CERTIFICATE OF APPROPRIATENESS

HPO File#: HP2026_0071

Proposal: Alteration/Addition – **Detached Garage Apartment Addition of 640 sq. ft.**

ELEVATIONS

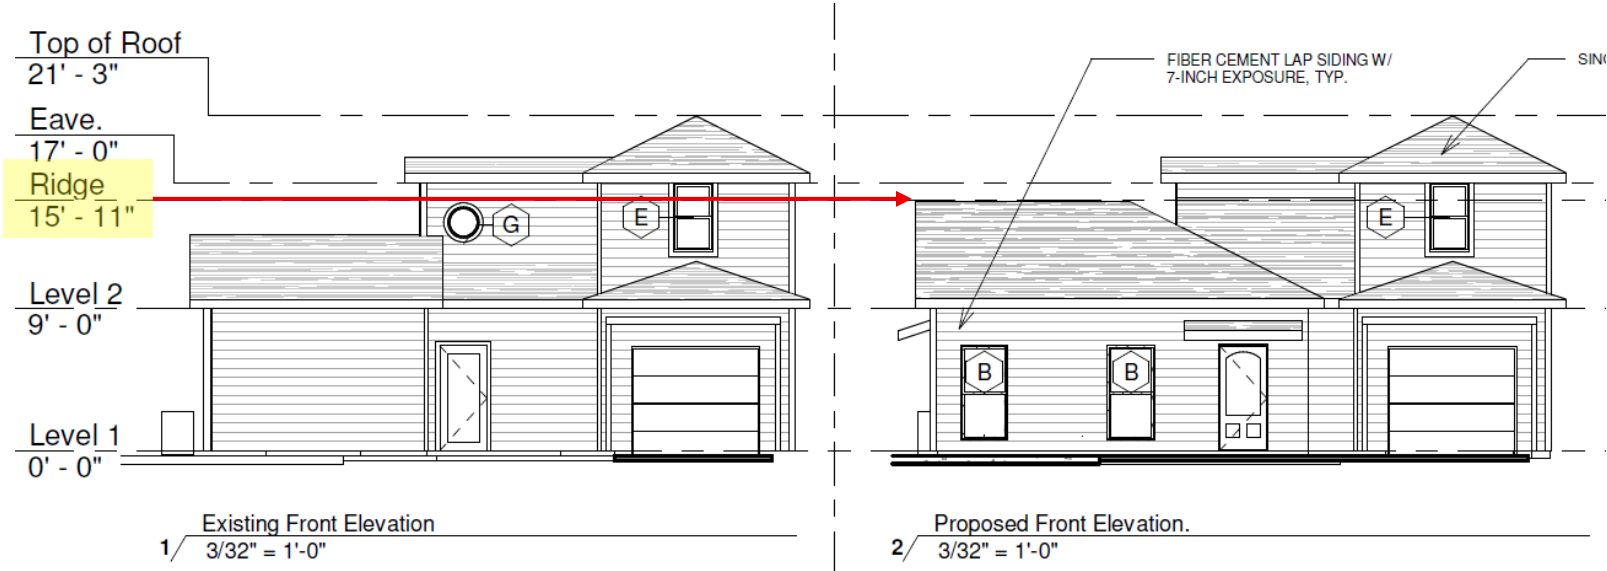
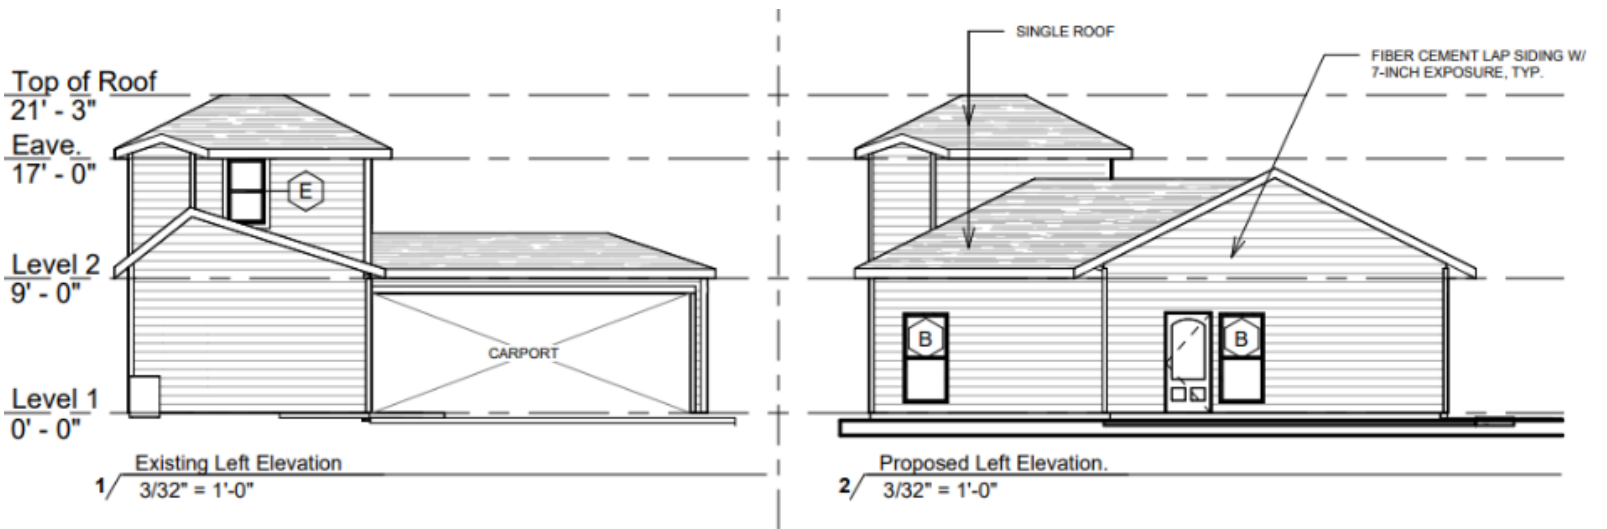
North Elevation

- Existing wood double hung window, 2nd story, to remain
- Proposed (2) horizontal wood frame picture windows, 1st story, 35 in x 55 in. (not visible from the street).

West Elevation

- Existing wood double hung window, 2nd story, to remain

ALL NEW WINDOWS MUST BE INSET 1¼ Inches – See Attachment

Single/Double Hung Windows Must Be Equally Horizontally Divided 1-over-1

ALL CEMENTITIOUS BOARD MUST BE SMOOTH

EAST ELEVATION (RIGHT SIDE)

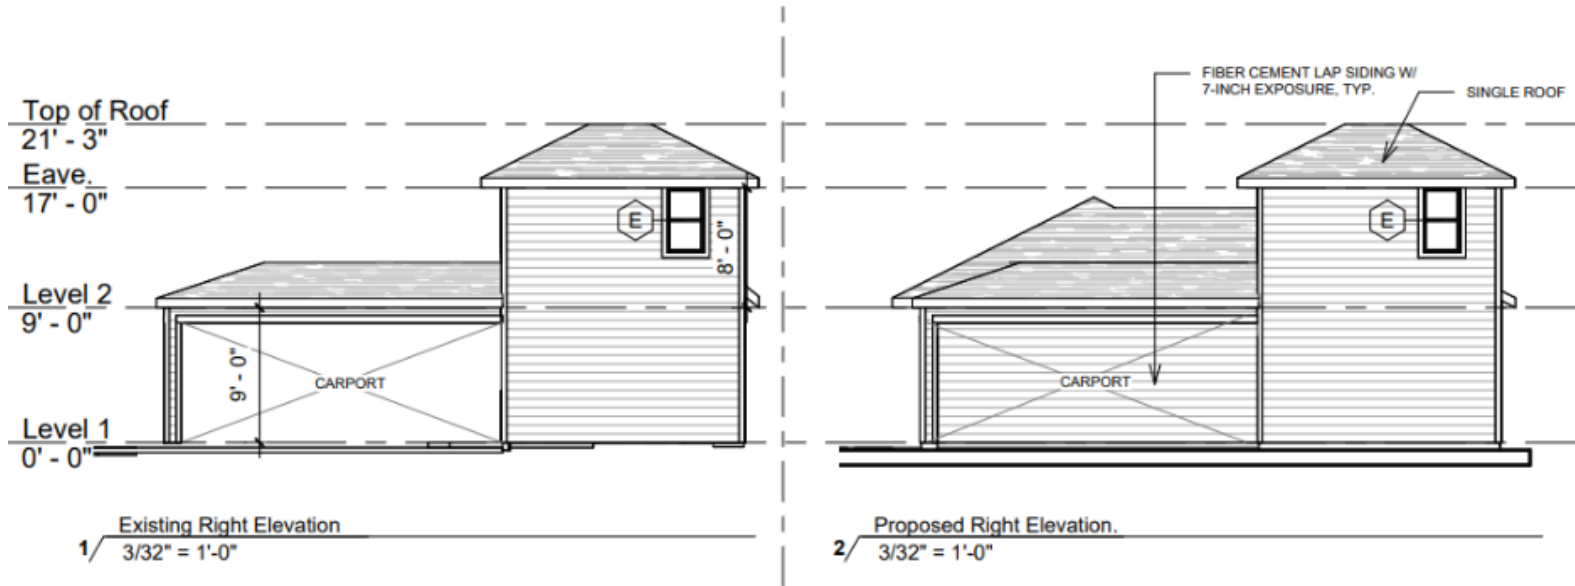
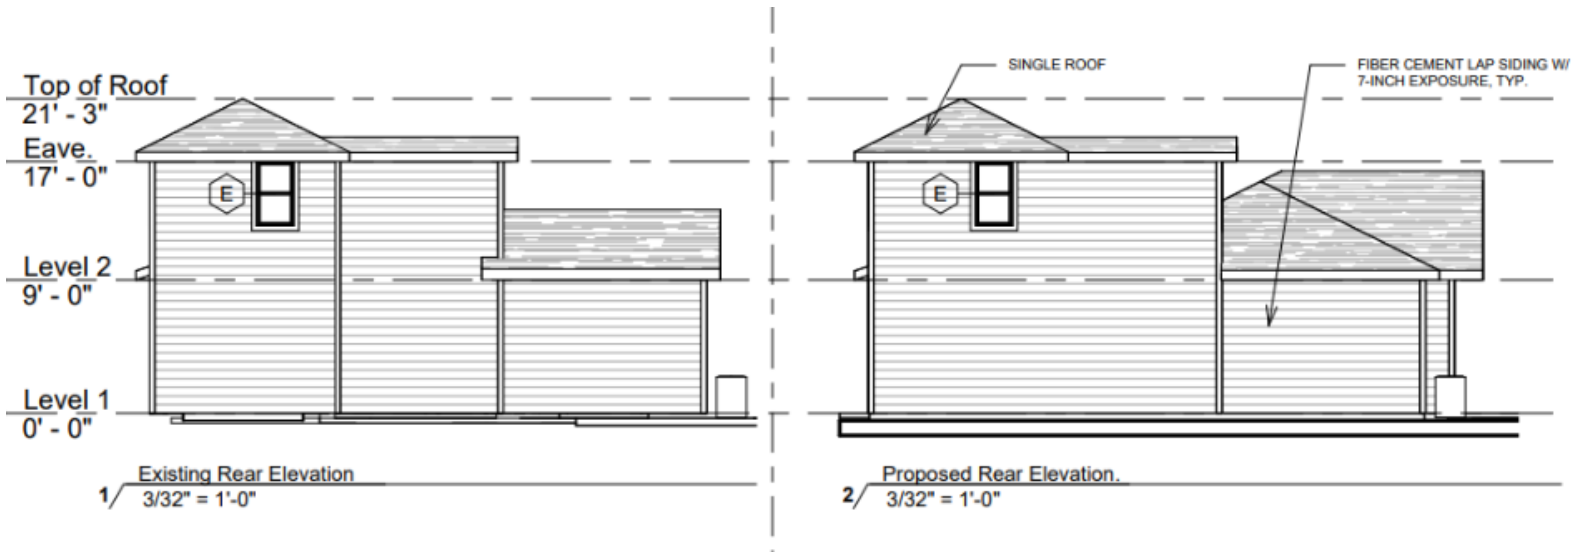
East Elevation

- Proposed (1) double hung wood window inset, set of double glass doors 3 lites each with overhead transom, (4) clerestory vertical picture windows

South Elevation

- Existing wood double hung window, 2nd story, to remain
